ADDENDUM #1**1.1 PROJECT INFORMATION**

- A. Project Number: 2026-11230
- B. Project Title: BEB On-Route Charging Infrastructure
- C. Project Location: STA's Valley Transit Center at 10501 E 4th Ave, Spokane Valley, WA & Liberty Lake Park & Ride at 22501 E Mission Ave, Liberty Lake, WA
- D. Agency: Spokane Transit Authority

STA Route 9 BEB Charging Addendum #1 Narrative

S-201

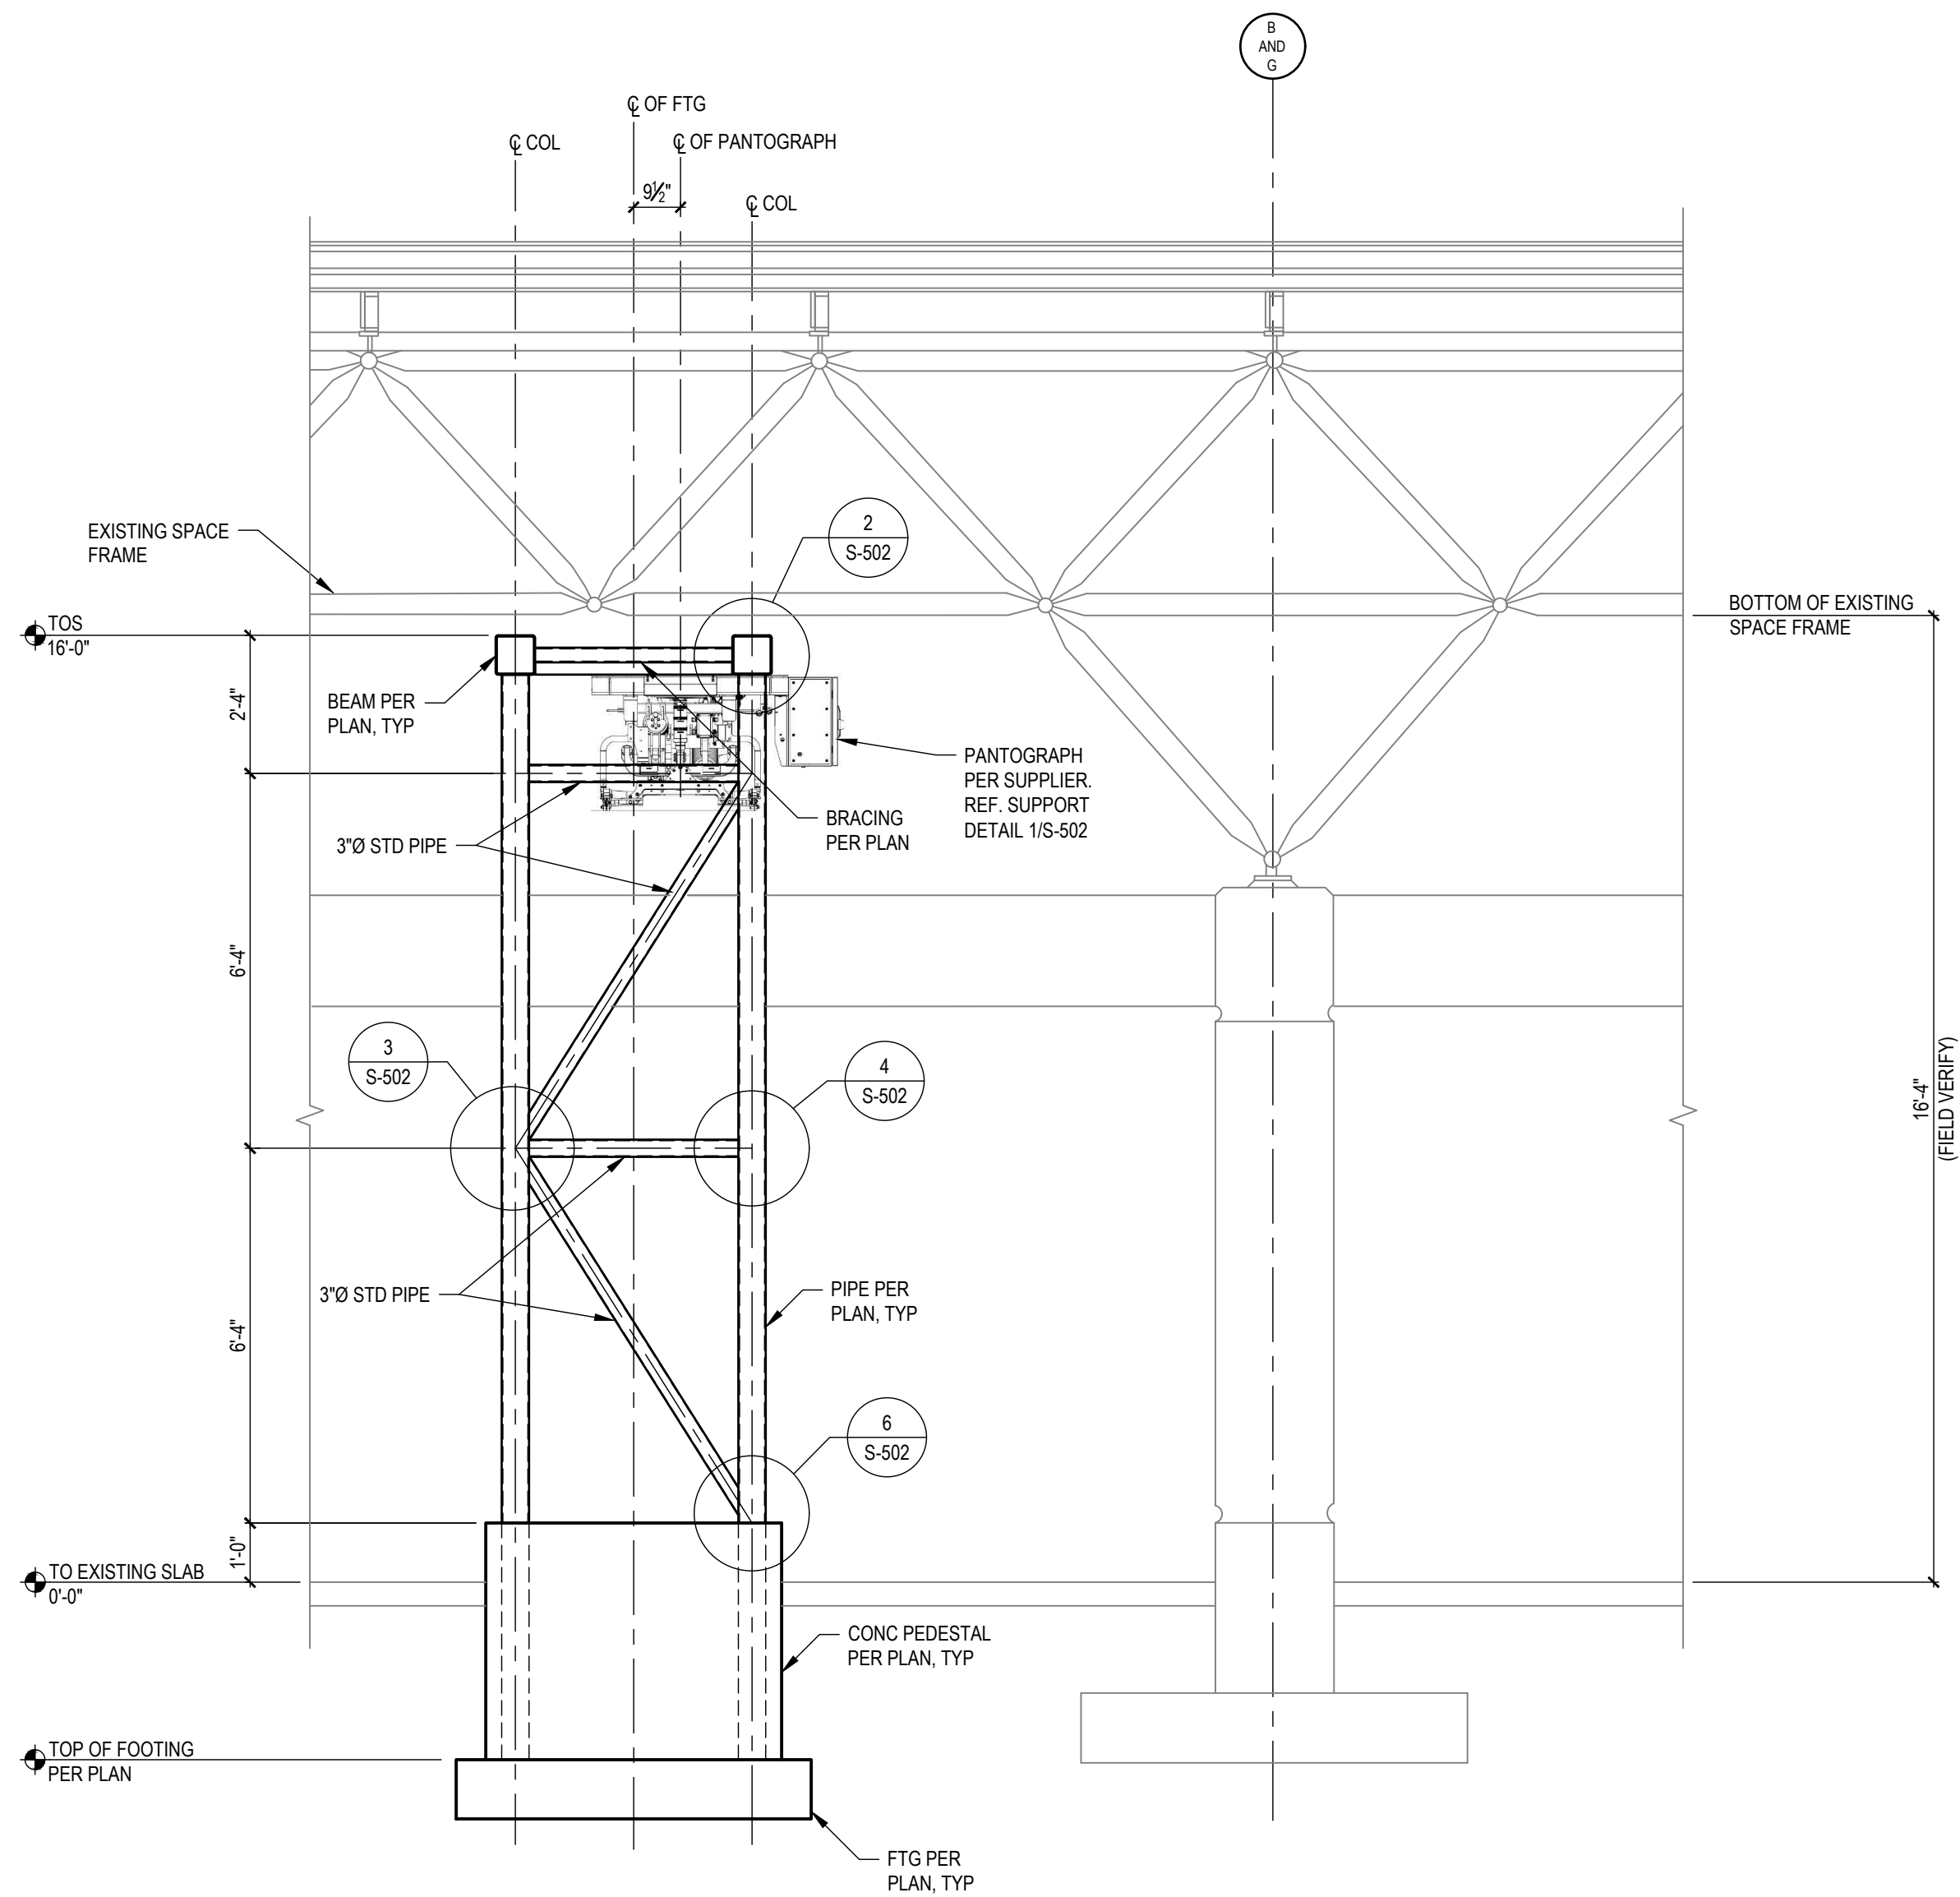
H. SHEET S-201 – STRUCTURAL ELEVATIONS

1. Added: Manufacturer specified pantograph height to elevation detail.

2 BUS STOP SHELTER FOUNDATION
SCALE: NTS

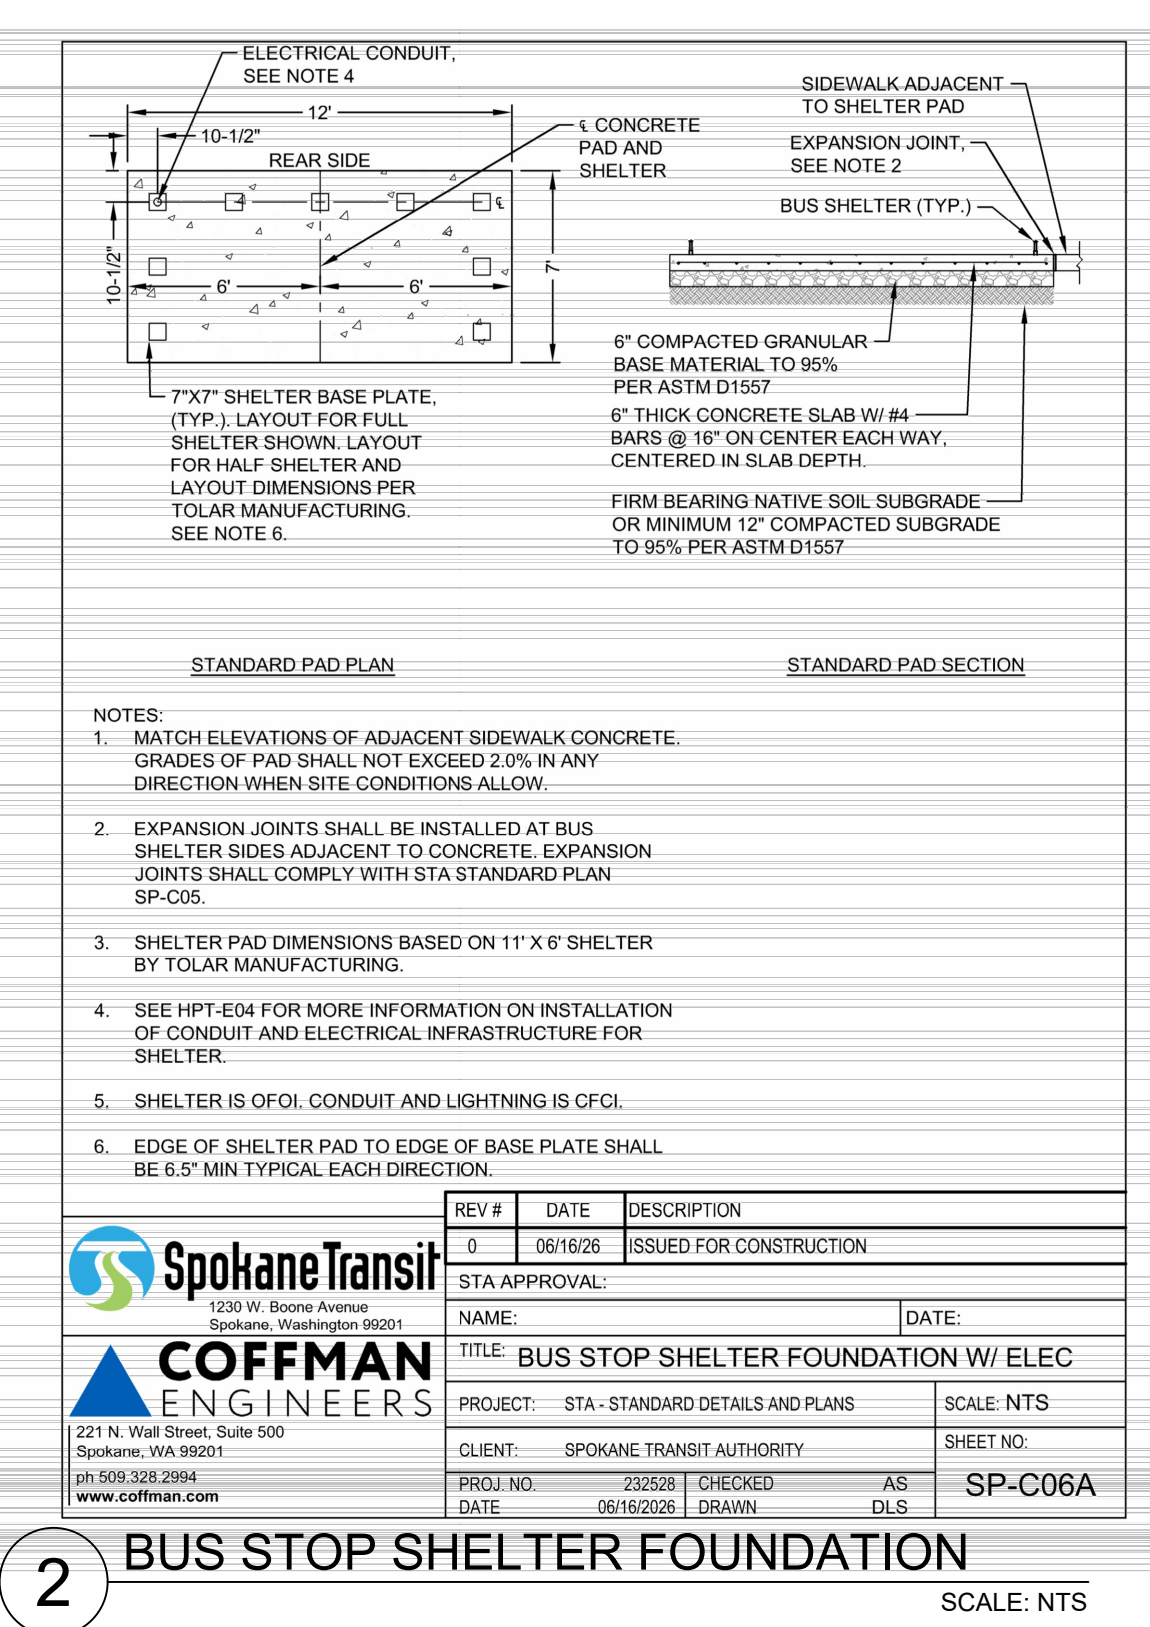
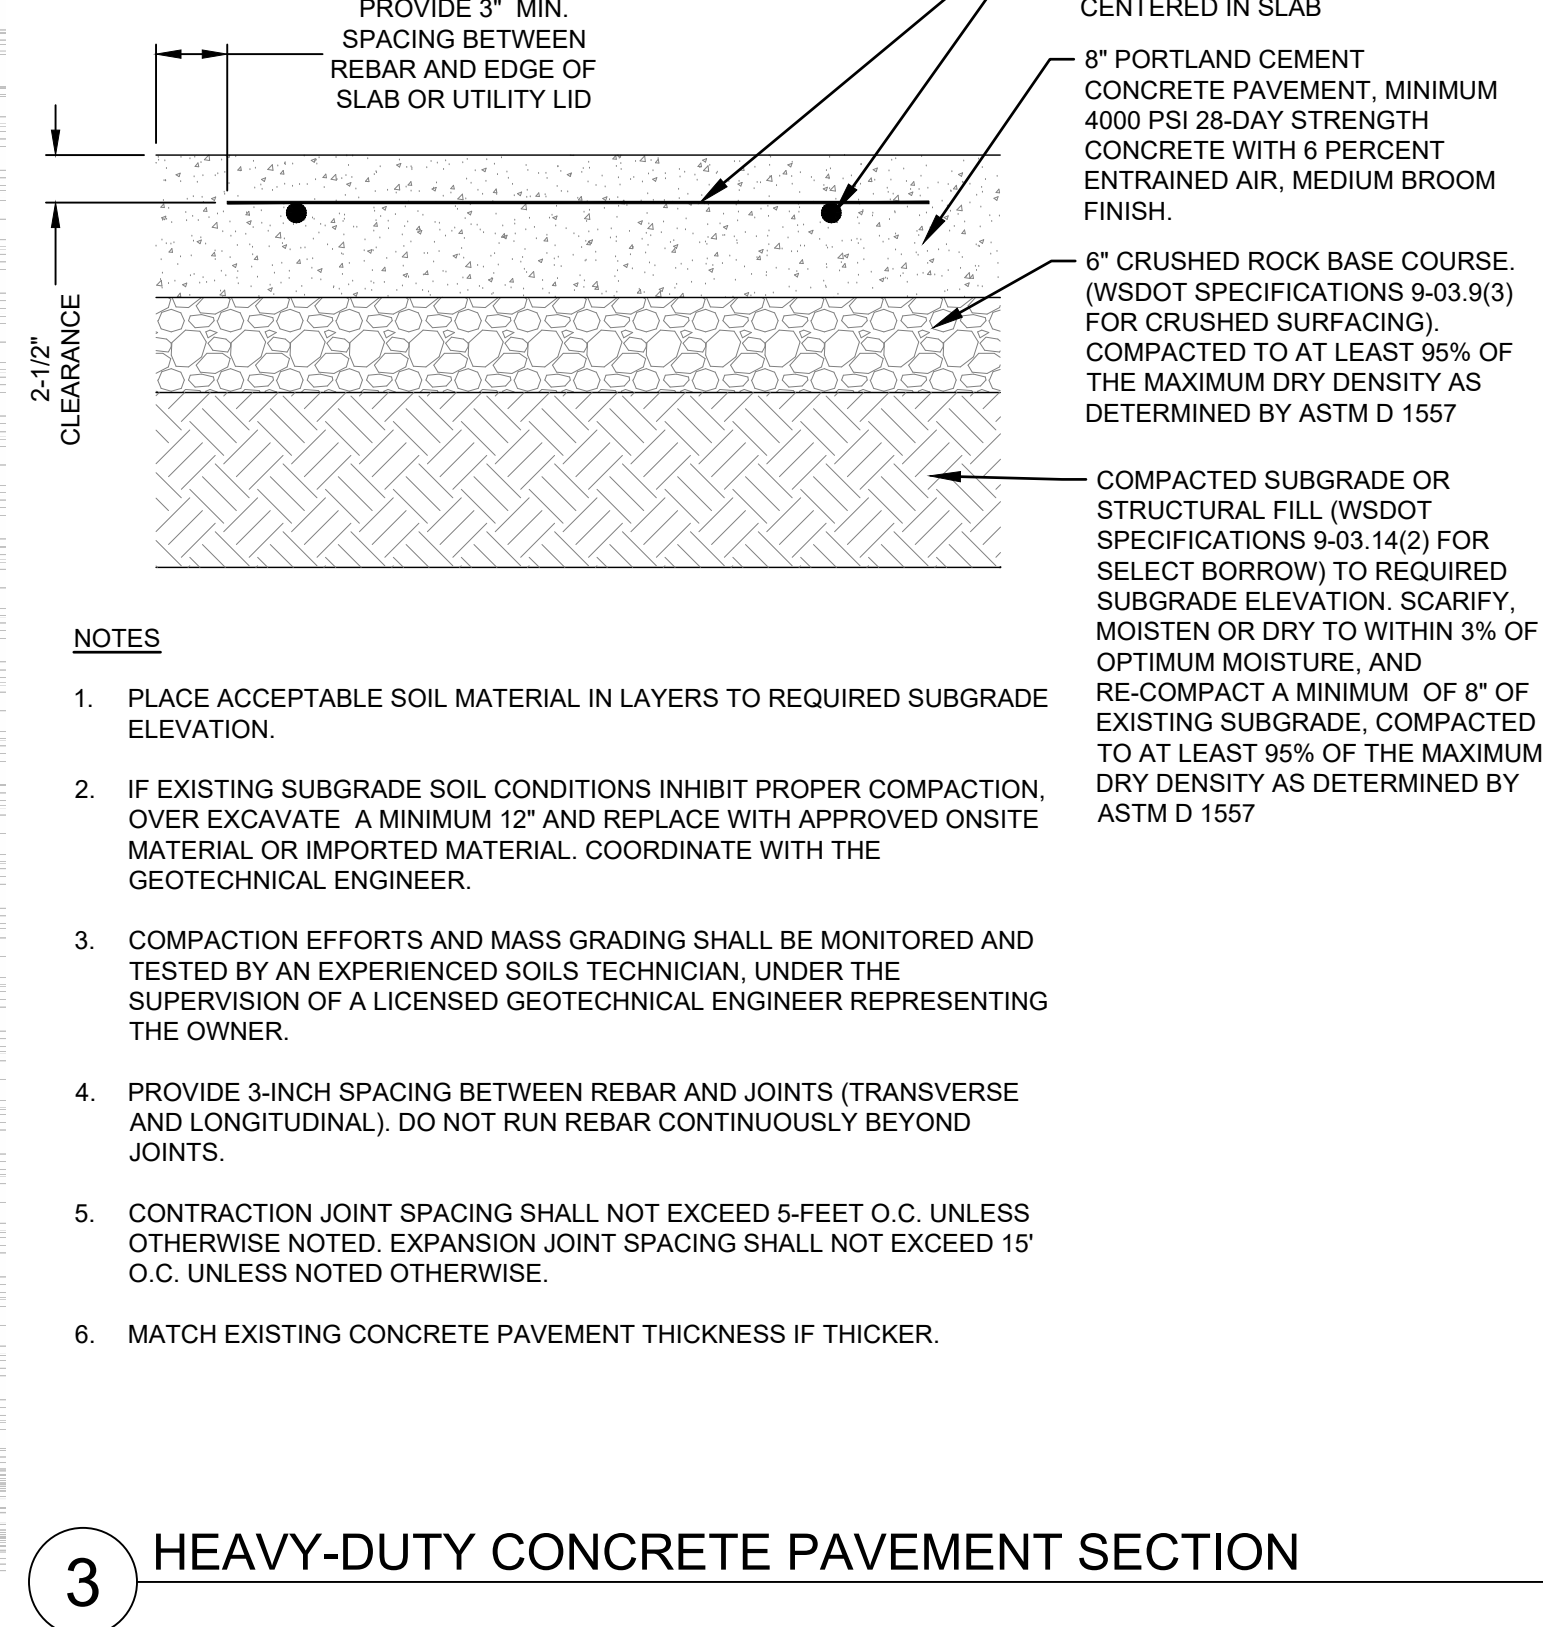
B. SHEET C-500 – CIVIL DETAILS

1. Revised: Detail 2 dimensions to reflect current version of Bus Stop Shelter Foundation standard detail.
